# Rezoning Transportation Analysis

Petition Number: 2022-155

General Location Identifier: 03715511

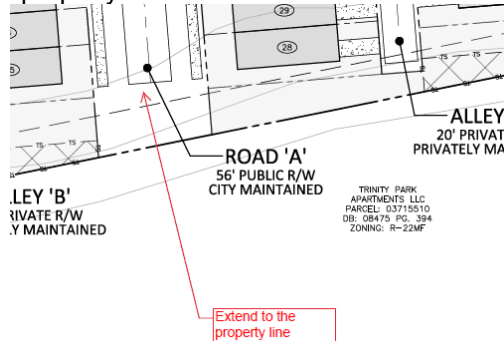
3. ~~Revise site plan and conditional note(s) to commit to dedicate 28 feet of right of way from the road centerline of Roadway A. The site plan shall label and dimension the right of way from the road centerline.~~

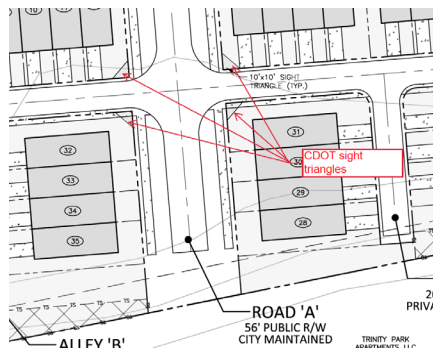
8. ~~Revise site plan and conditional note(s) to commit to clearly identifying Road A as standard from the CLDSM. Add standard to the callout of road A as well as add a conditional note committing to constructing roadway A to a CLDSM standard. Site plan shall label and dimension roadway infrastructure from the roadway centerline including ROW.~~
9. ~~Revise site plan and conditional note(s) to commit to clearly identifying Alley cross sections as a standard from the CLDSM. Add standard to the callout of alleyways as well as add a conditional note committing to constructing them to CLDSM standard.~~
10. ~~Revise site plan by dimensioning the sidewalk along Alley A.~~
11. ~~Revise site plan by adding CDOT sight triangles to the intersection of Alley A and Roadway A per CDOT sight distance policy. Show either the 50 x 50 sight triangle or the 35 x 3 sight triangle.~~
